BW1 Block Diagram

Size Custom	Document Number	Alviso VGA/DMI (2/5)		Rev 4A
Date:	Thursday, August 11, 2005	Sheet	5 of 72

Rev.	Date	Phase	Change List
1A	2005/1/4	DV	Initial release
2A	2005/2/5	SIV	See page 69 Record A
3A	2005/4/25	SIT	See page 71 Record B
4A	2005/7/5	SVT	See page 72 Record C

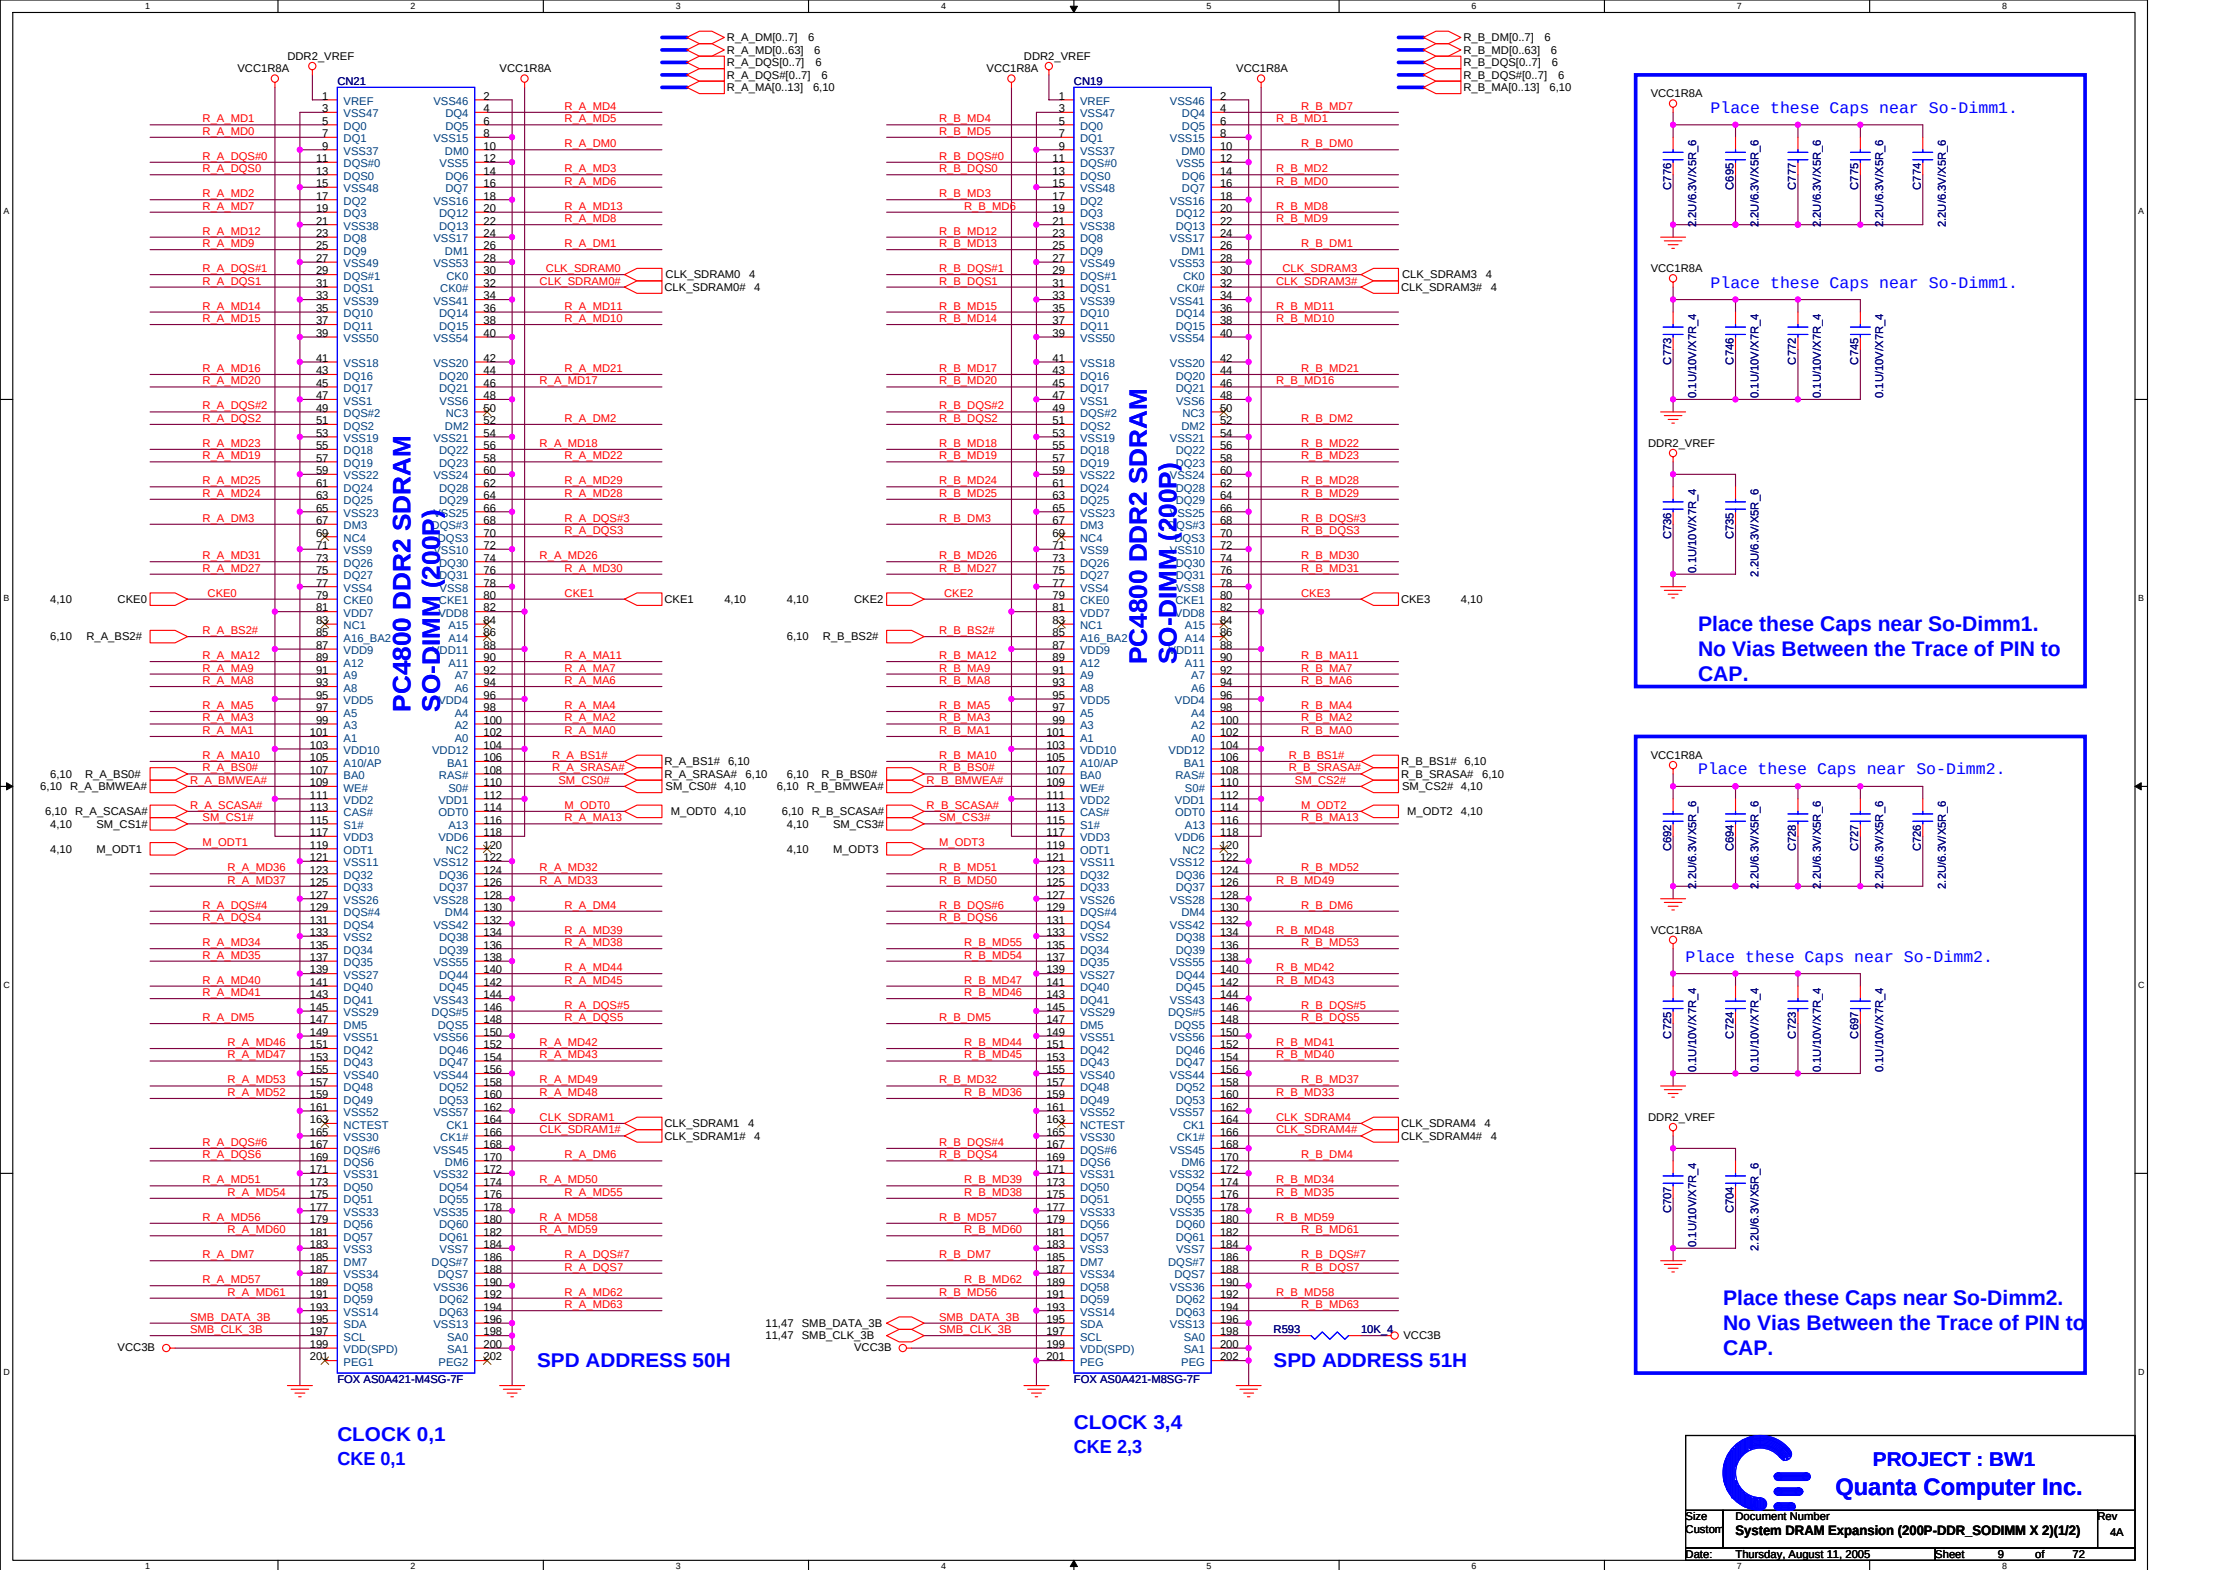
EC A66

EC A65/37/Size of resister R33 on LAN_MAG_TAP changes to 1608 size.(IBM EC)
EC A66/5/Change termination resister R364 for Alviso composite TVout from 150ohm to 75ohm.(IBM EC)
EC A67/37/Delete a gate logic from docking PCIE_WAKE# signal.(IBM EC)
EC A68/16,23,27/change value of resistors and signal name on Azalia interface.(IBM EC)
EC A69/25/Add internal MIC Bias logic.(IBM EC)
EC A70/12/Change diode to cheaper one.(IBM EC)
EC A71/50/PJ2(DC-IN connector) change to right-angle type.
EC A72/52/PJP2,PJP3(Battery conn.) change to 7-pin. type.
EC A73/55/PL12 change to GANSHIN(CDRH104RNP-5R2NC-EP).
EC A74/12/ATI TV-OUT termination R304,R308 change to 150 ohm.
EC A75/12/Add R683=0ohm, change R195,D19 to NI per Atmel recommend.
EC A76/32/R109 change to 1K,R115 change to 1.2K,C156 and C166 change to 12pF to pass IEEE test.
EC A77/7/Add C816-C819 edge capacitors to meet Intel design guide.
~~EC A78/11/Install U10,U11,U42 and change to TC7SZ08.Change damping resistors' value to solve PCI clock slew rate too slow issue.~~

Size	Document Number	Rev
Custom	USB Ports	4A
Date:	Thursday, August 11, 2005	Sheet 22 of 72

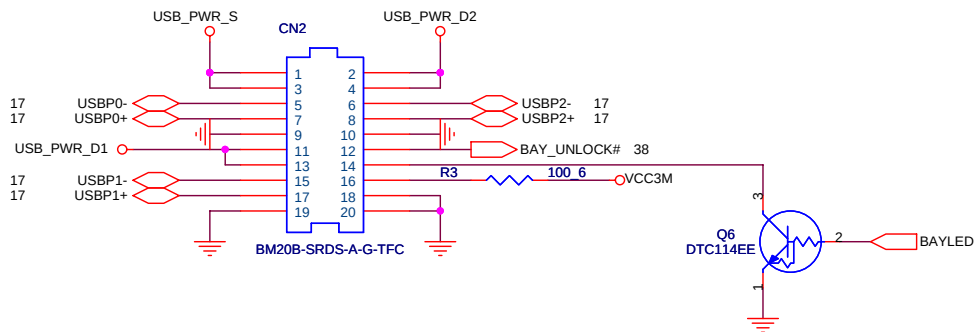
Change to 20pin board to board connector
2004/11/11 Thunder

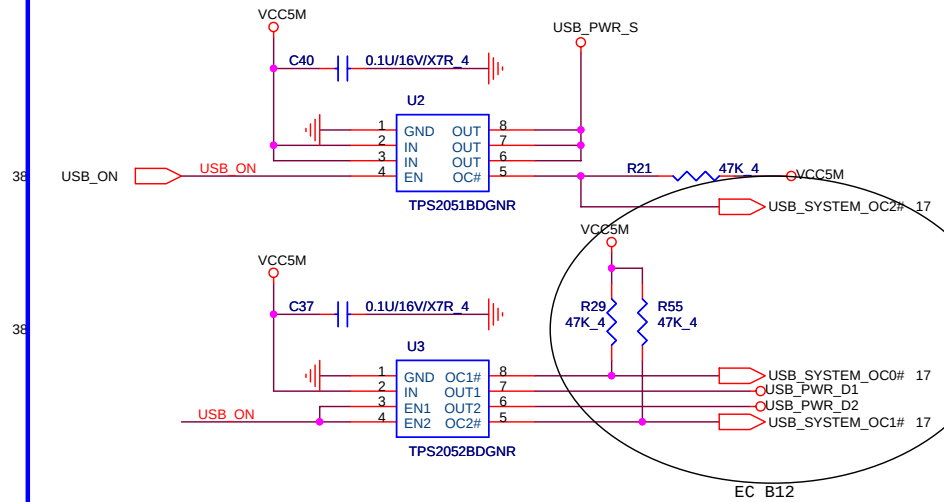
Change to TI solution (TPS2051 + TPS2052 power switch)
2004/12/09 Thunder
